June 18, 2004

Refer to: HSA-10/B-127

In your May 22 letter, you requested the Federal Highway Administration's acceptance of a box-beam guiderail to bridge rail transition design as a test level 4 (TL-4) design for use with several standard bridge railing designs currently used in New York. The design was successfully crash tested to TL-3 at the Texas Transportation Institute (TTI) and documented in that agency's April 2004 report entitled "NCHRP Report 350 Test 3-21 on the New York State DOT (NYSDOT) Modified Box Beam Transition to 4-Rail Steel Bridge Rail." This design is shown in the enclosure to this letter.

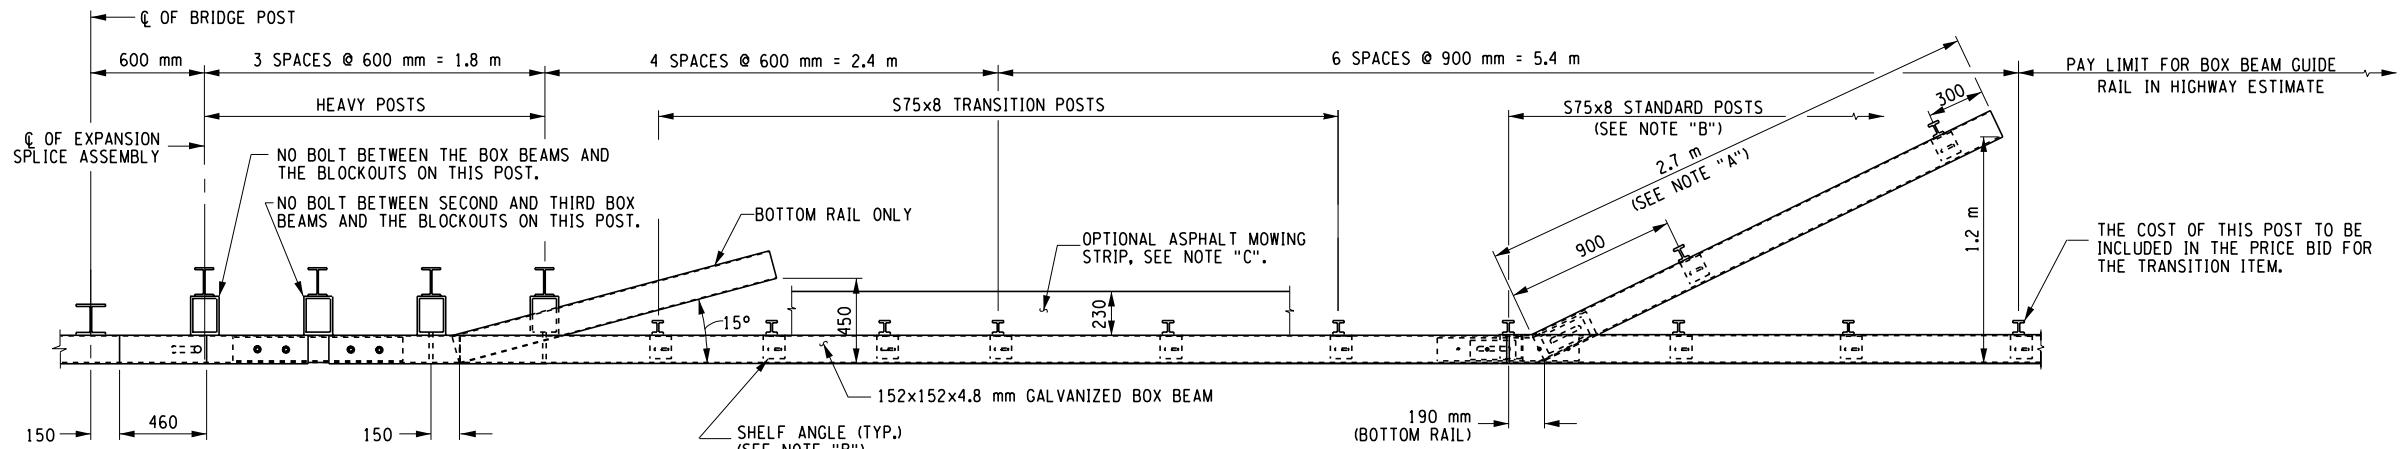
Although not physically tested when connected to a concrete safety shape bridge railing, TTI completed a finite element analysis of this configuration and predicted that this transition when used in conjunction with a curb that blocks out the lower leading edge of the concrete safety shape would likely meet NCHRP Report 350 evaluation criteria at TL-3. Based on this analysis, I will consider the NYSDOT designs BD-RC 3, BD-RC13-R1, and BD-RC16-R1 at <http://www.dot.state.ny.us/caddinfo/structures/bd.html> to be acceptable also.

ALL DIMENSIONS ARE SHOWN IN MILLIMETERS UNLESS OTHERWISE NOTED		
ISSUED		STATE OF NEW YORK DEPARTMENT OF TRANSPORTATION STRUCTURES DESIGN AND CONSTRUCTION DIVISION
REVISED	STEEL BRIDGE RAILING TO BOX BEAM GUIDE RAIL TRANSITION	
	APPROVED:	
	DEPUTY CHIEF ENGINEER (STRUCTURES)

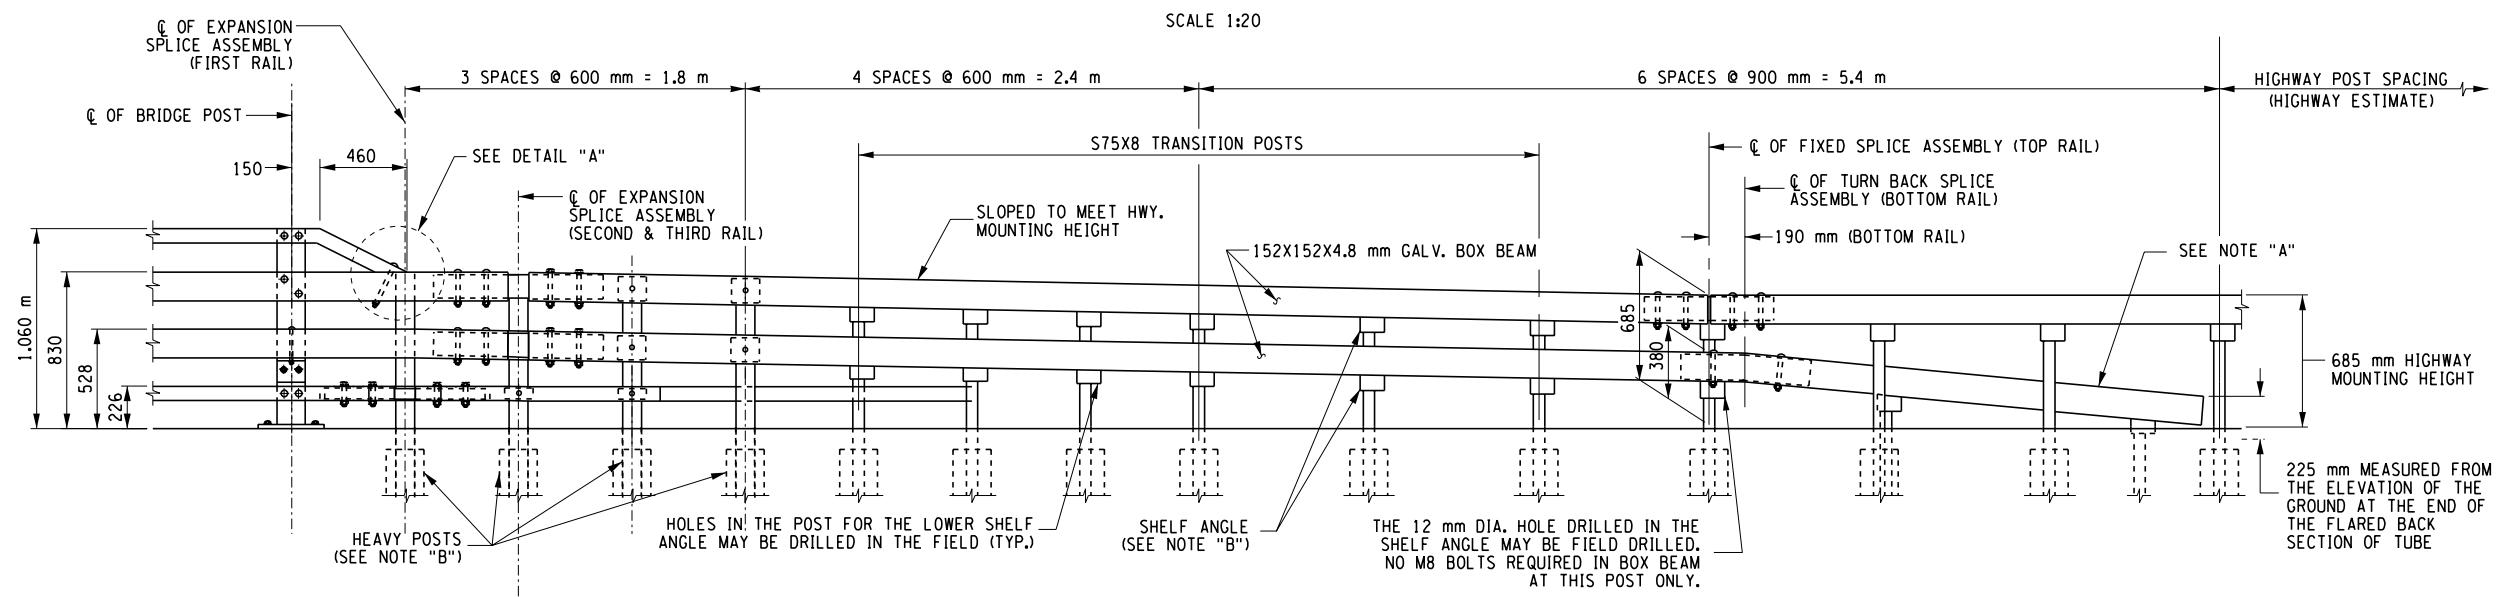
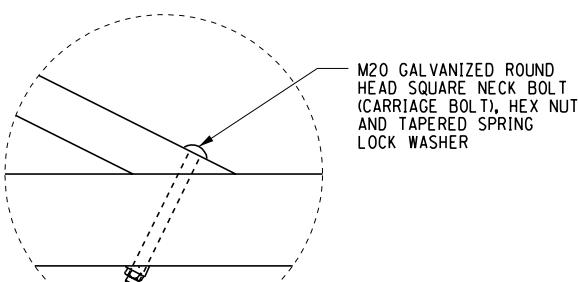
Based on the successful test of the transition to a 4-rail, deck-mounted bridge railing, you also requested acceptance of this transition design when connected to a two-rail bridge rail with a brush curb, a three-rail design flush-mounted, a four rail design mounted behind a sidewalk, and a five rail combination rail design. Each of these applications may be considered acceptable with the following caveats:

- With the two-rail curb-mounted bridge rail, the lower rubrail is not used, so the curb must be flared away from the roadway and extended under the transition to reduce the likelihood of a vehicle's wheel snagging on the leading edge of the curb.
- With the three-rail bridge rail, the design remains as tested, but the fourth rail is eliminated.
- With the five-rail design, the added upper rail may be terminated in a manner similar to the fourth rail in the tested design or flared behind the fourth rail.
